MELFA Technical News

BFP-A6079-0131E October 2014

Corporate Logo Change for the Teaching pendant (T/B) Subject:

Applicable to: T/B for S series and F series

T/B " R32TB \nearrow R32TB $-\square$ \nearrow R33TB \nearrow R33TB $-\square$ " old and new difference.

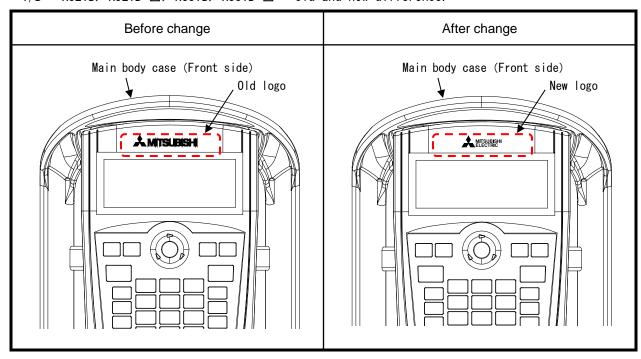
The corporate logos of the T/B will be changed from "MITSUBISHI" to "MITSUBISHI ELECTRIC":

Before change		After change	
★ MITSUBISHI	\Rightarrow	MITSUBISHI

T/B " R56TB/R56TB- \square /R57TB/R57TB- \square /R46TB " old and new difference.

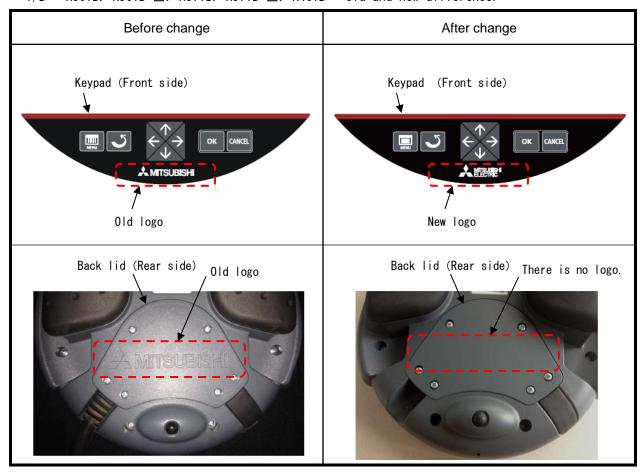
→	Schedule	Keypad	Back lid	
	After October 2014	Old logo	There is no logo.	
	After December 2014	New logo	There is no logo.
